ASSESSMENT REPORT

Austar Coal Mine Modification (DA 29/95 MOD 4)

Figure 2: Location of proposed longwall A5a

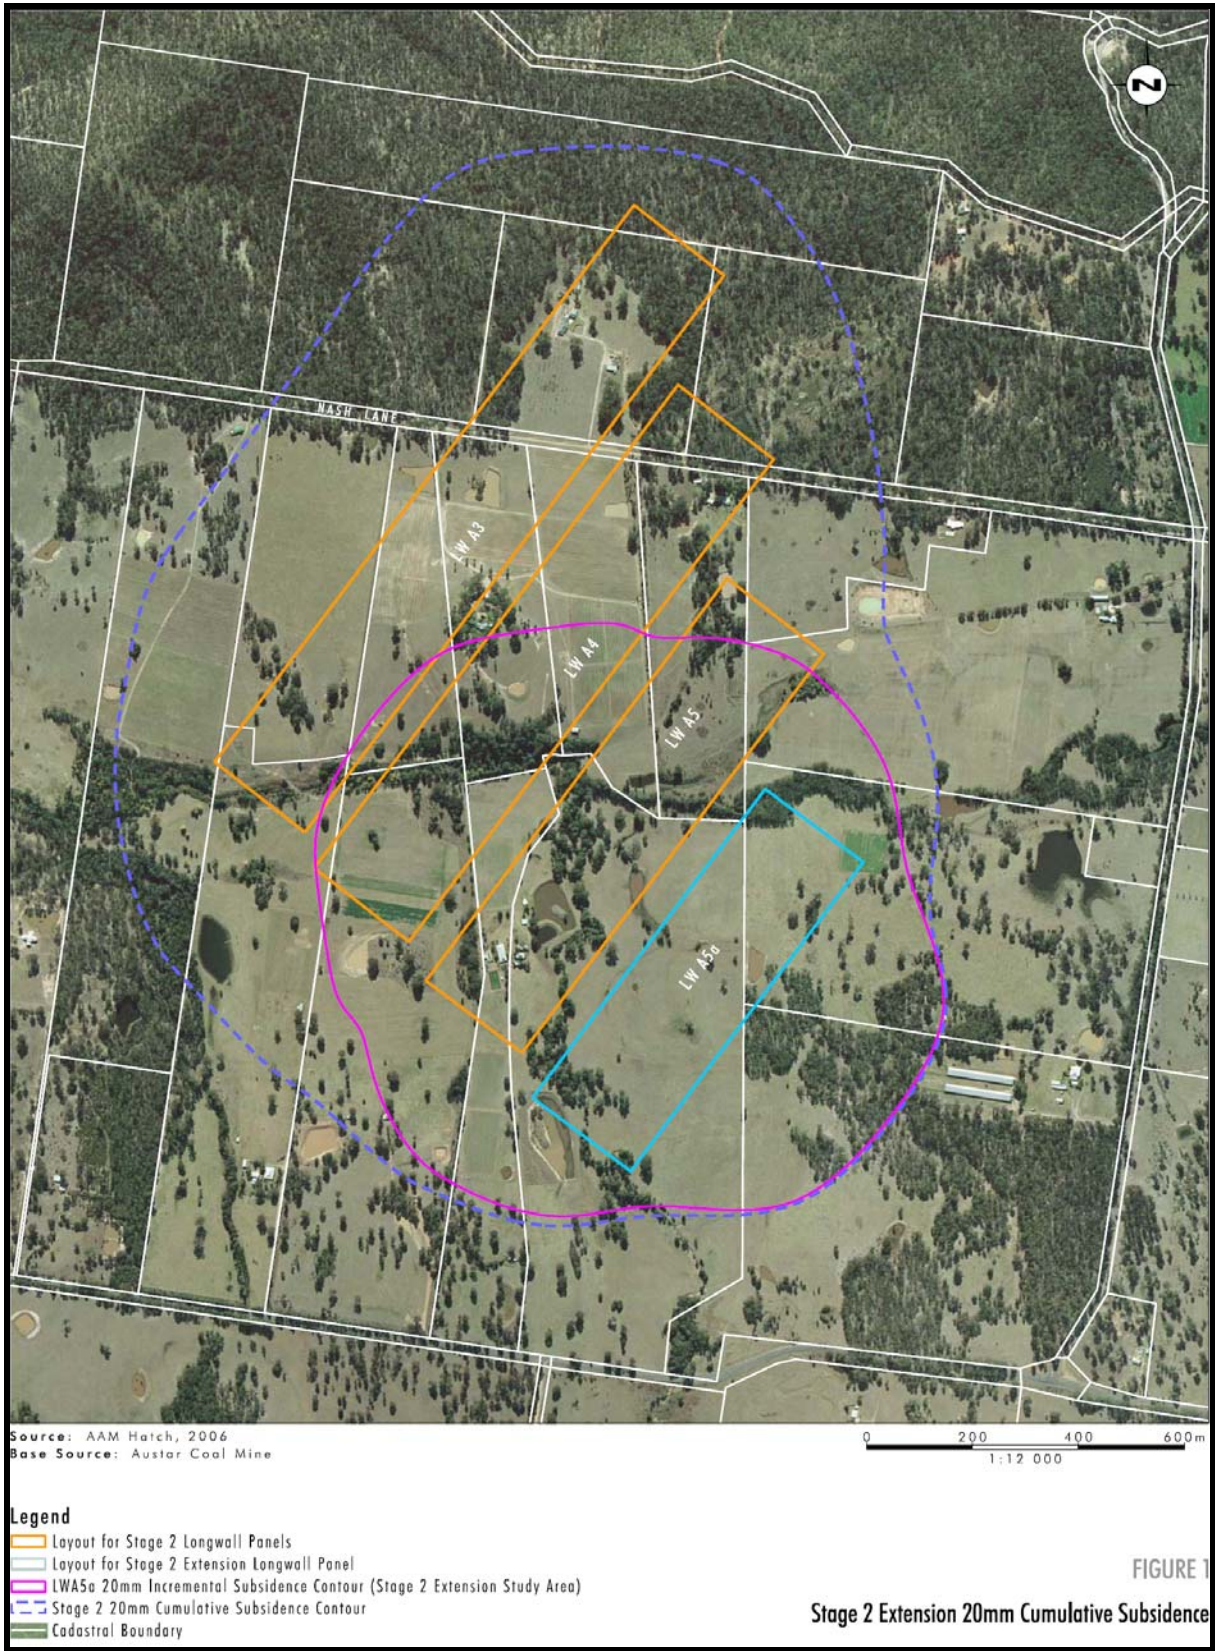
Therefore, to maximise coal production whilst the ventilation shaft is constructed, and to allow sufficient time to investigate potential revisions to its Stage 3 mine plan, Austar proposes to modify its development consent to mine an additional longwall panel in the Stage 2 mining area, adjacent to longwall A5 (longwall A5a – see Figure 2). Austar also proposes to use LTCC in longwall A5a, to achieve a similar extraction height as in longwalls A3-A5.

Figure 3: Cumulative subsidence profiles after mining longwalls A3 – A5a and longwall A6

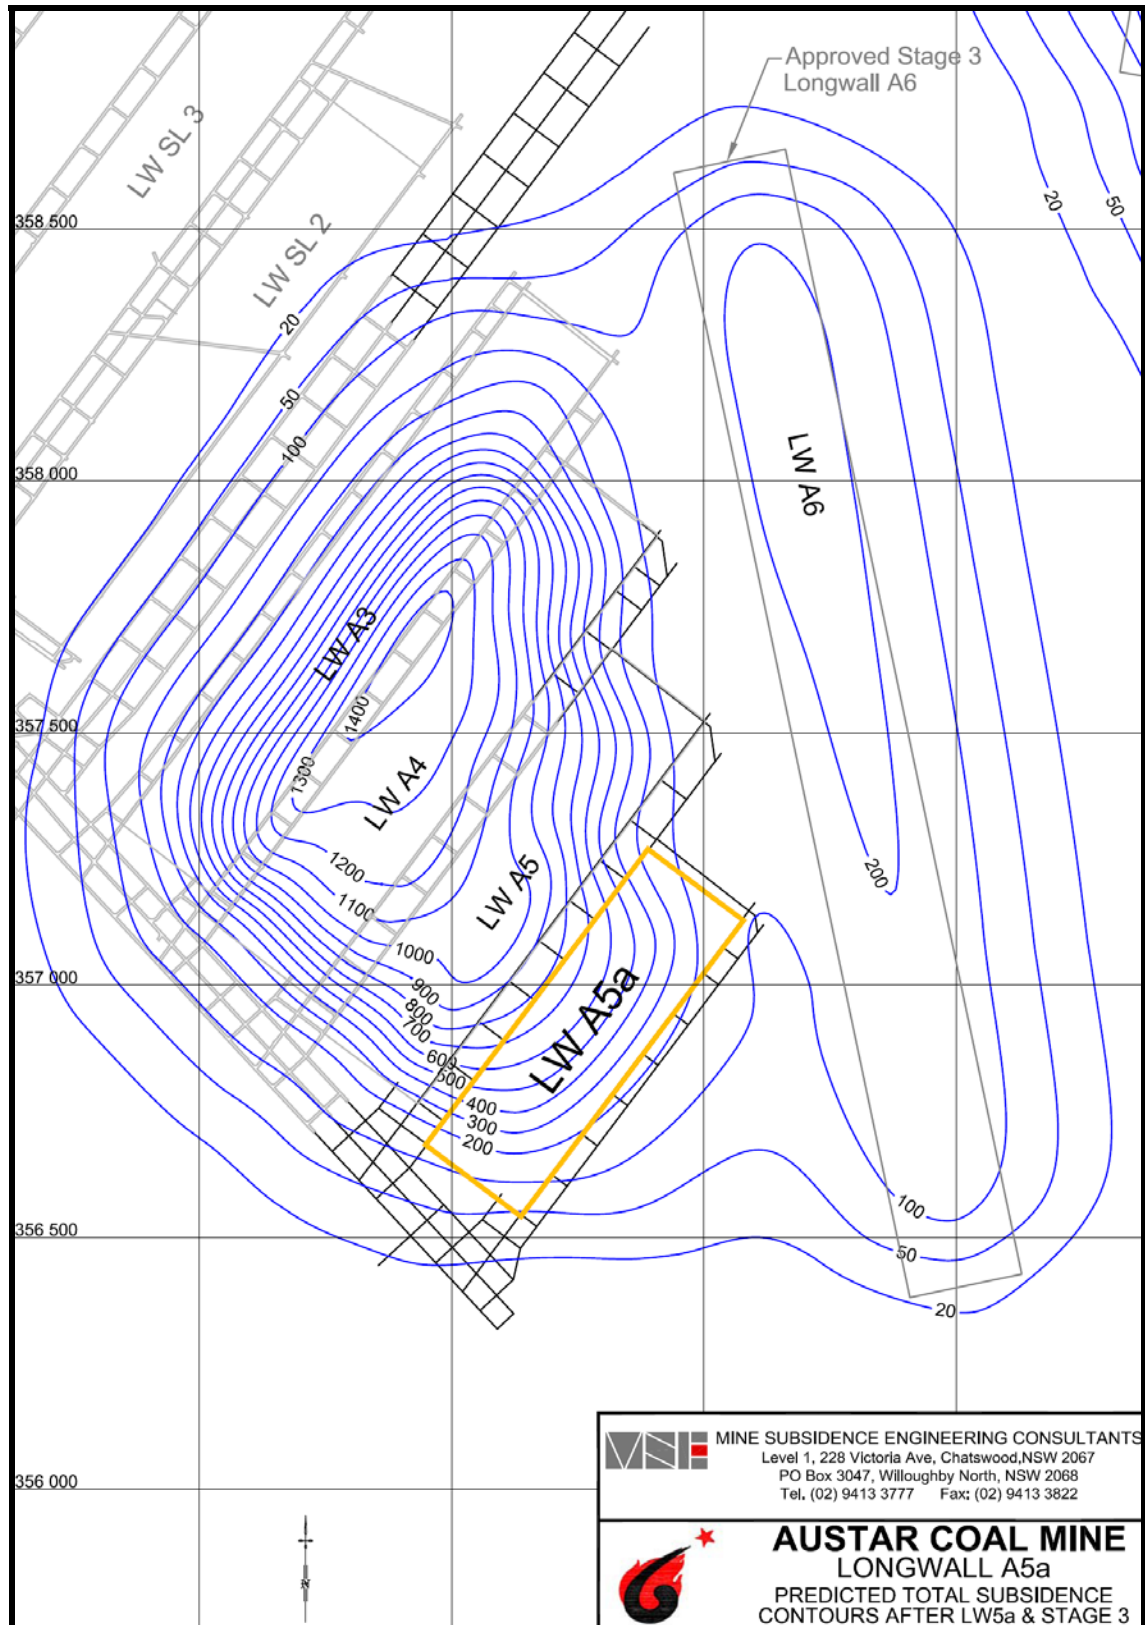
The EA included a specialist subsidence impact assessment (SIA). The SIA presented both the predicted and upper-bound subsidence levels. The SIA also included a cumulative assessment, which took into consideration the overall subsidence of longwalls A3-A5a and the potential subsidence profile of the proposed longwall A6, in the Stage 3 mining area (see Figure 3). The SIA found that the maximum subsidence levels that would be expected following extraction in longwall A5a would be similar to that predicted for longwalls A3 – A5 (see Table 1).

The upper-bound subsidence level is equivalent to 65% of the extracted coal seam thickness, which is typically the maximum subsidence level which is experienced in the Newcastle Coalfield. Austar uses the upper-bound subsidence level as a risk assessment tool, and the Department recognises that these levels represent an absolute worst-case subsidence scenario. Austar predicts that the maximum cumulative vertical subsidence after extraction of longwall A5a would more likely to be close to the predicted subsidence level. The Department notes that monitoring following completion of longwall A3 showed that the actual recorded subsidence was less than the predicted levels. The Department also notes that the depth of cover to longwall A5a is greater than the depth of cover to longwalls A3-A5.

In addition, the Department notes that the modelled subsidence predictions are based on recovering 6.5 m of coal throughout the length of each longwall panel in the Stage 2 mining area, and while approval to extract up to this maximum seam height from longwall A5a is sought, the actual extraction height would vary throughout the panel, dependent on geological features. The Department therefore considers that the overall level of surface subsidence following longwall A5a is unlikely to be significantly different to that previously assessed and approved for longwalls A3–A5, and that the maximum upper-bound subsidence predictions and associated impacts are unlikely to result. I&I NSW shares this view.
